Historic Architectural Review Commission Staff Report for Item 9

Application Number: H2022-0017

Address: 627 Caroline Street

Description of Work:

EAST ELEVATION (PROPOSED)
1/4" = 1'-0"

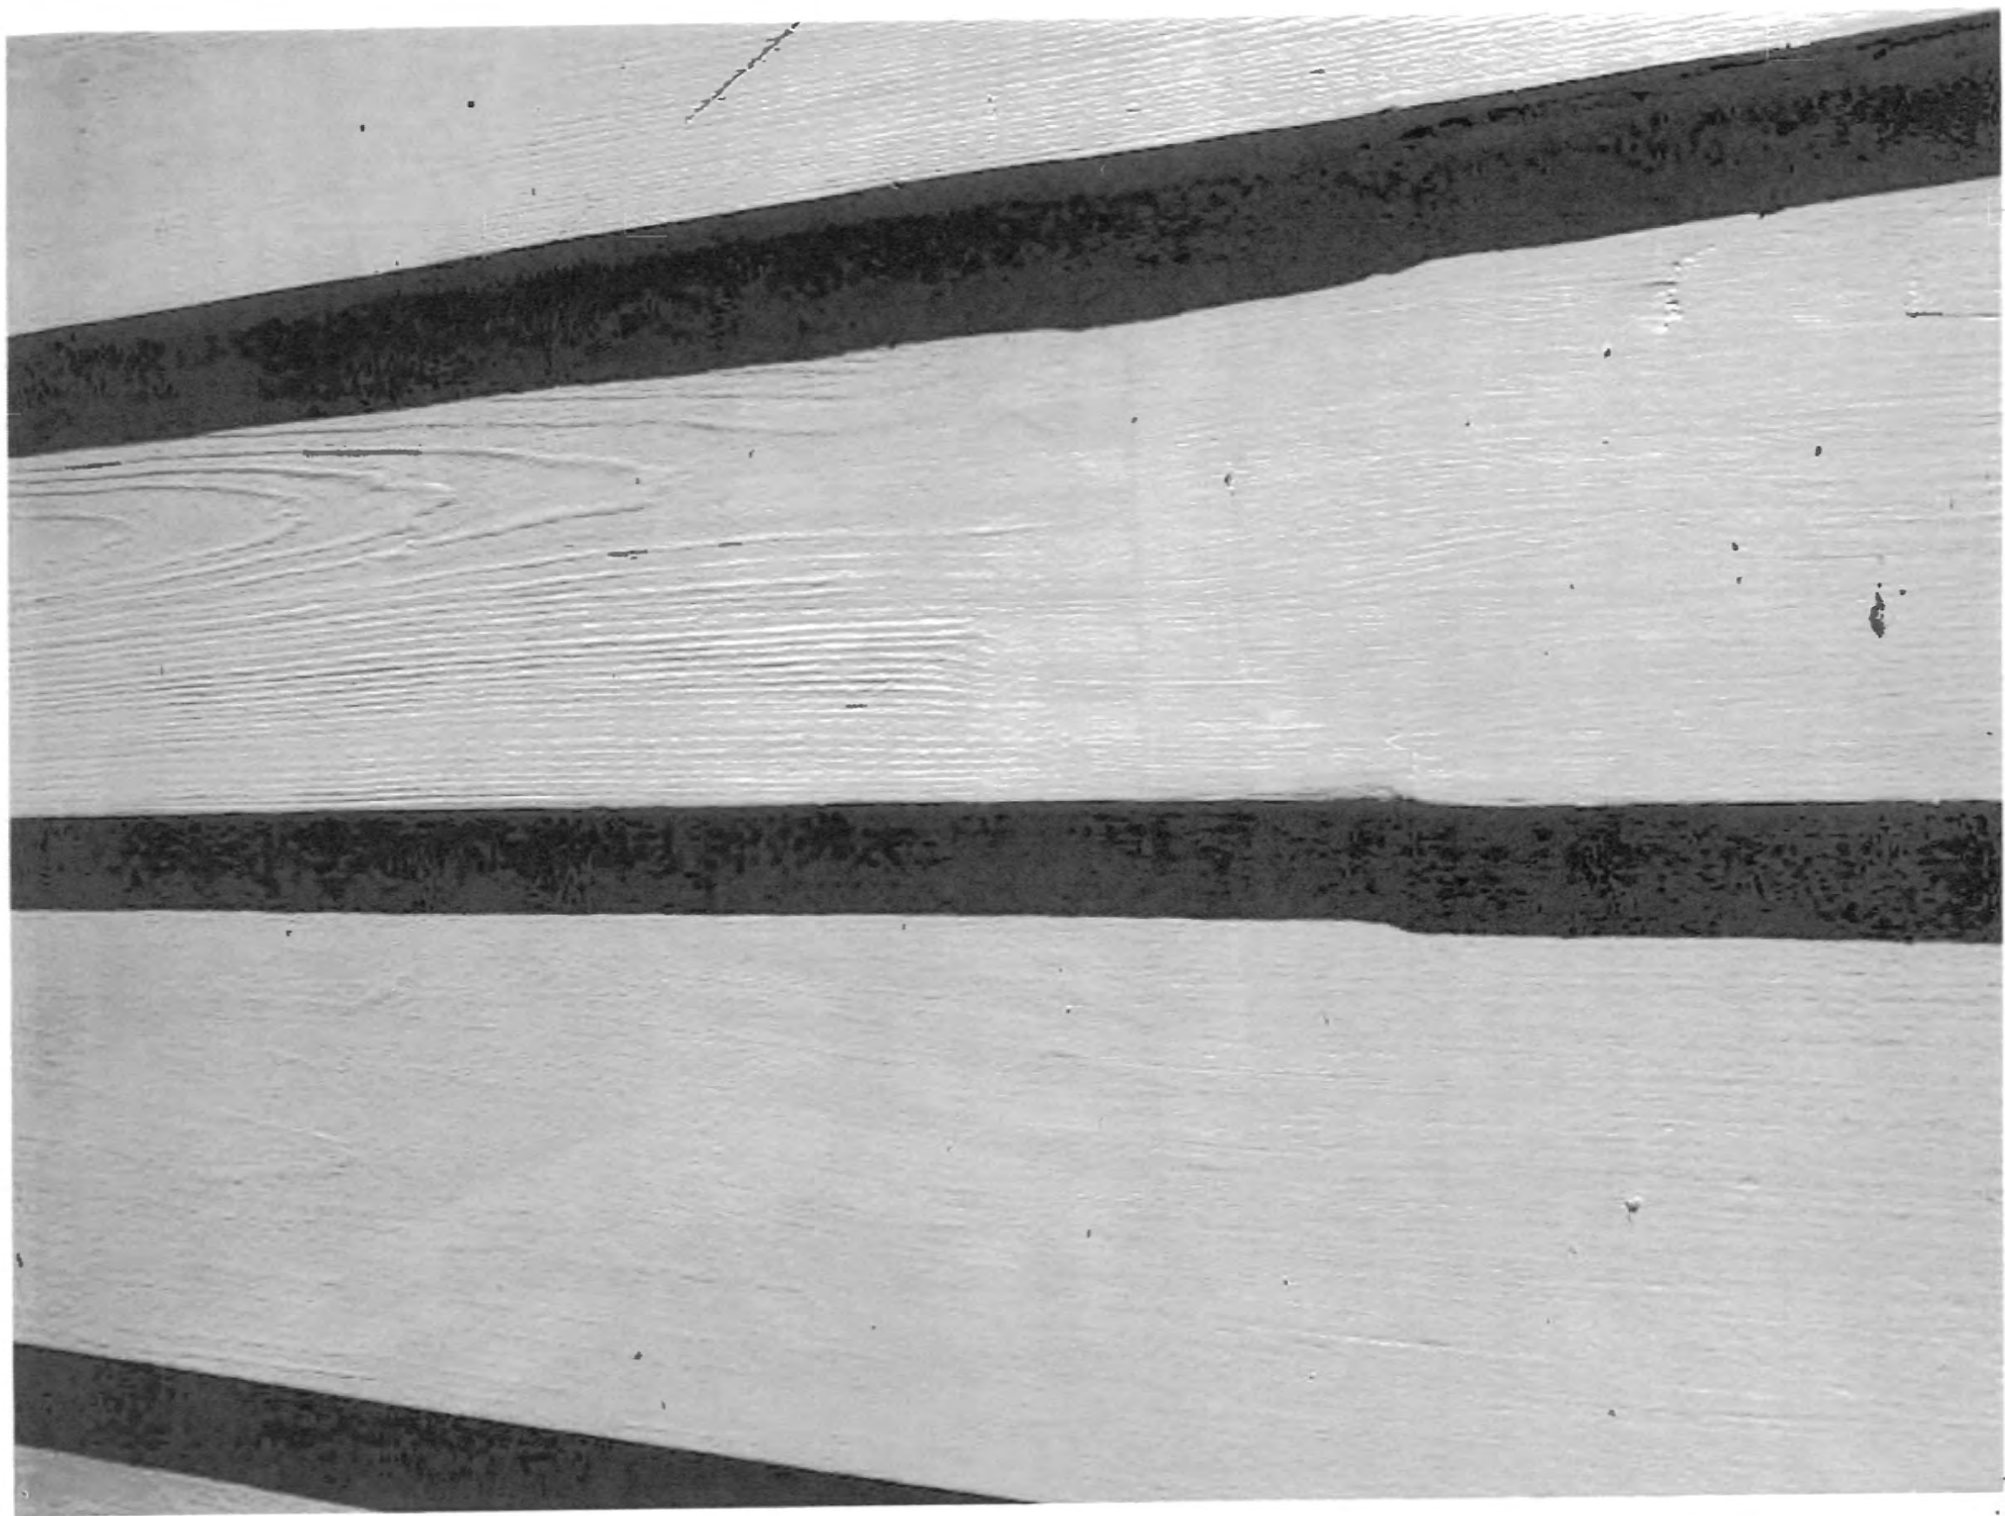
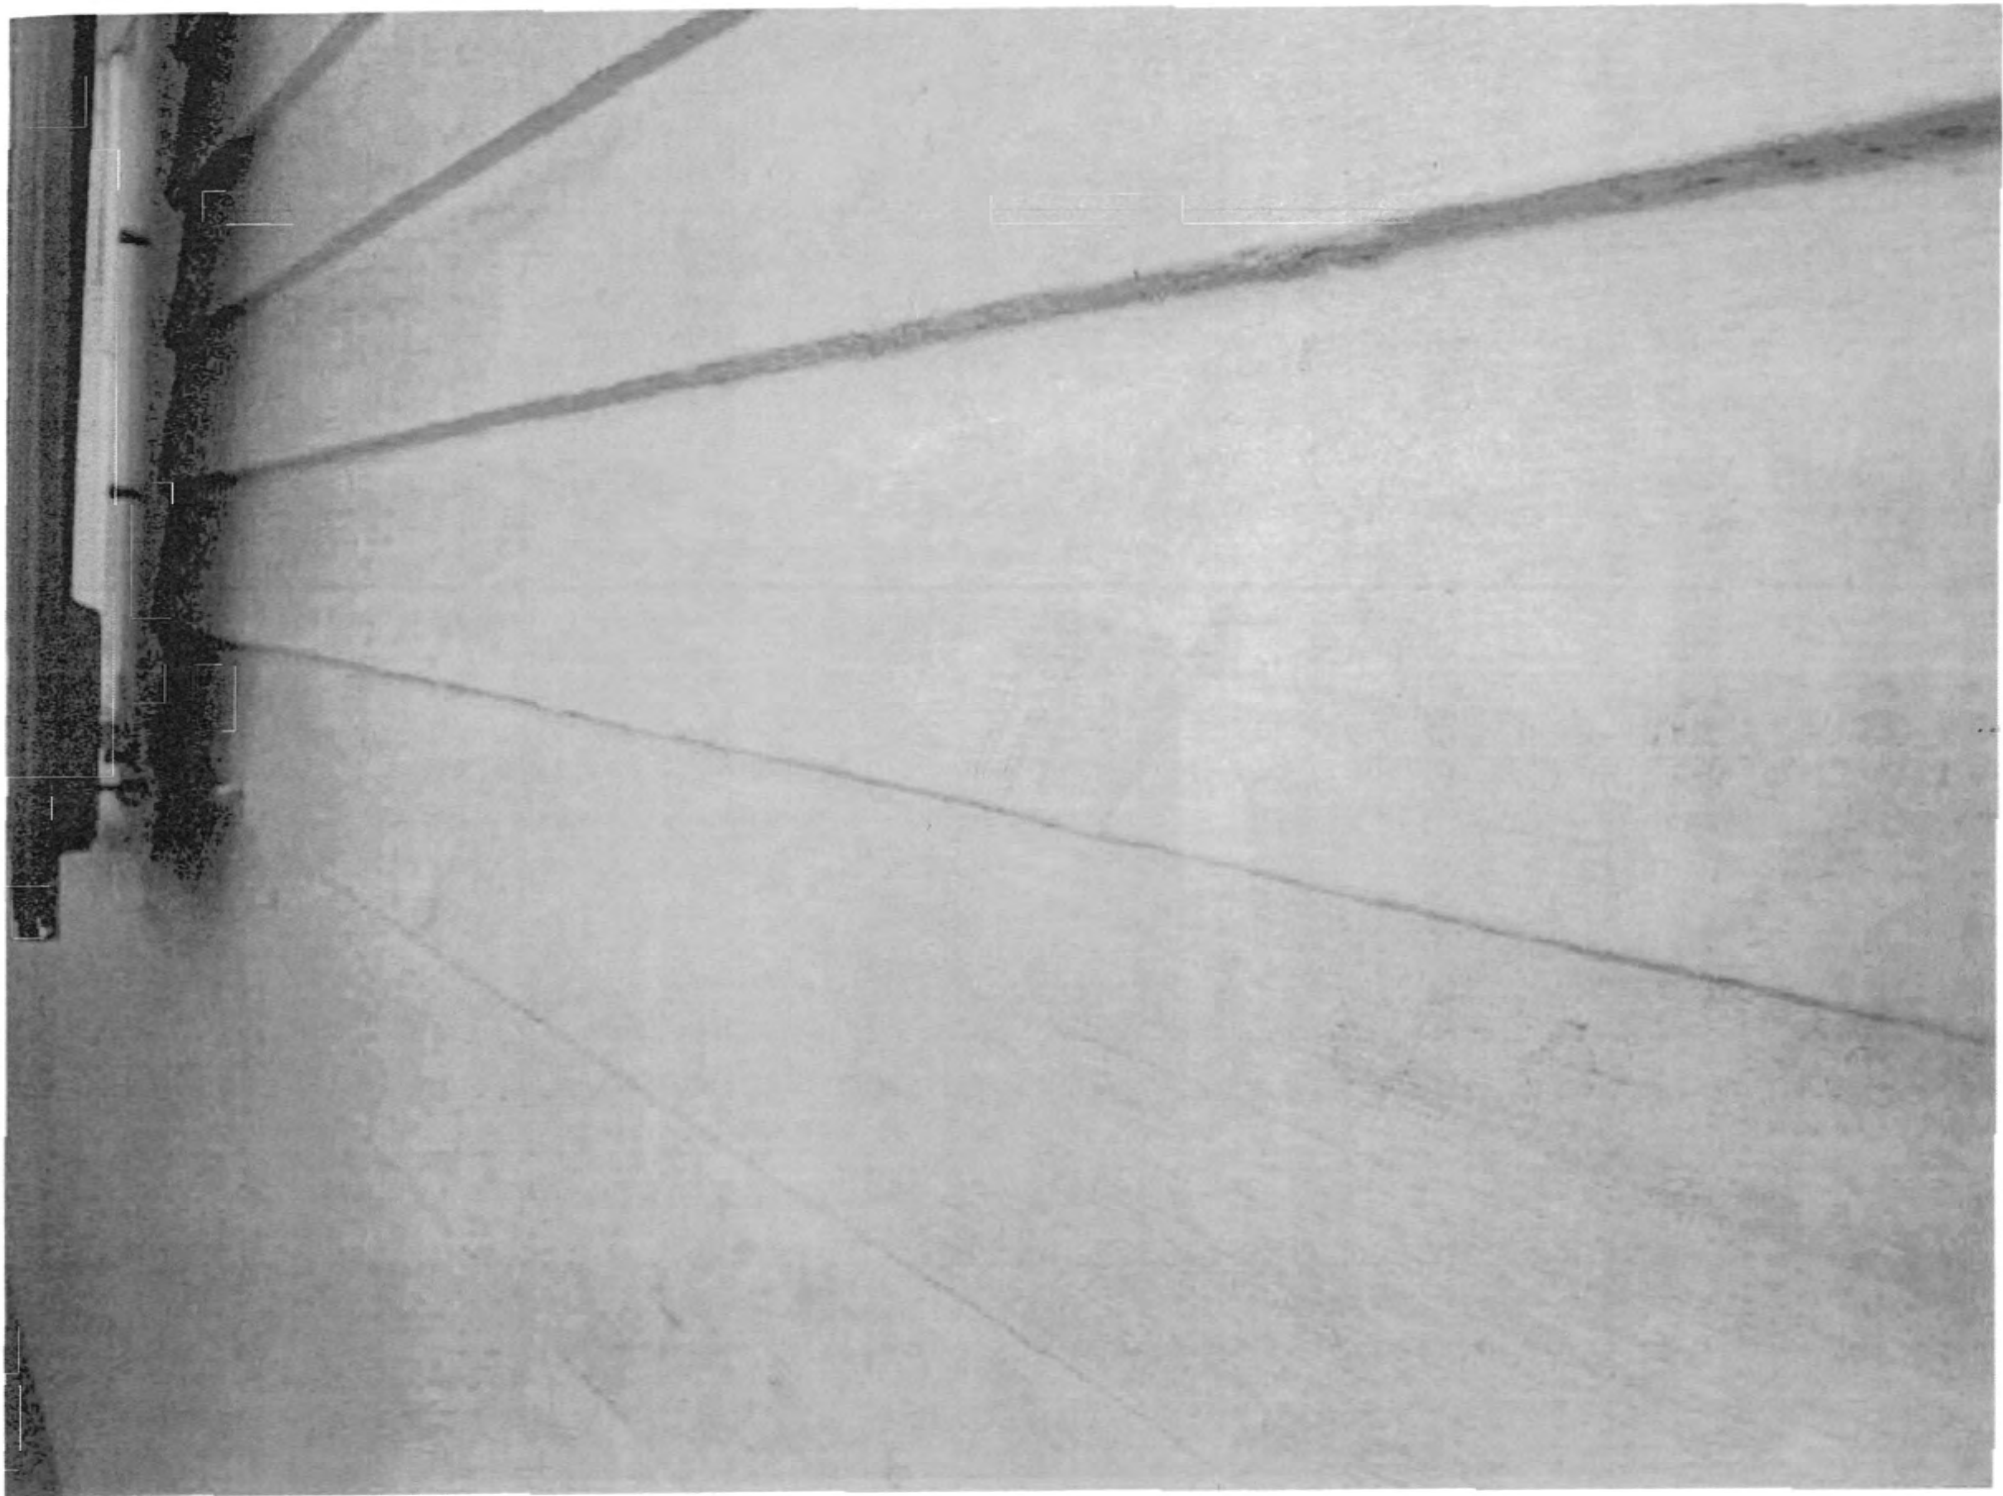
1. Change of 6" by 6" front porch columns to 8" by 8" columns with capital, trims, and bases.
2. Removal and disposal of old pine wood lap siding, when the plans included repairs and replacement when needed and replacement of all with new.
3. Removal and disposal of old gingerbread railings from second floor front porch and replacement with 44 ½" high railings. Wood turned balusters were used.
4. New gingerbread railings for first floor porch replaced with turned wood railings.
5. Higher new foundations than approved ones.
6. Dintel details on the front step's raisers.
7. Carport was built closer to the house.

Front Elevation from Building Permit 2019-1640. Building permit plans are signed by Architect William Rowan. Annotations in red on drawings signed by Architect Carlos Rojas and provided by the contractor for this review.

It is staff's opinion that we cannot approve a final inspection for this project as the contractor deviated from what was approved by this Commission and by staff through the permitting process. Moreover, what was built is inappropriate and inconsistent with cited guidelines and the Secretary of the Interior's Standards for Rehabilitation. Removal of historic materials and departing from approved plans without approved revisions is against the principles and regulations that HARC is responsible for. The historic character of the house has been compromised by adding conjectural elements, by changing the proportions and scale of the front porch and destroying architectural features and fabric that once were part of the house.

The railing has been changed from an unauthentic gingerbread pattern to a correct round spindle design that is similar to matching buildings all around it. This is more historically accurate and by necessity meets the current code for railings.

Column bases and some trim work were added to the columns. The columns now have proper capitals and a recess panel, more in keeping with the upscale nature of the historic house. These details are also found in surrounding structures of similar age and design.
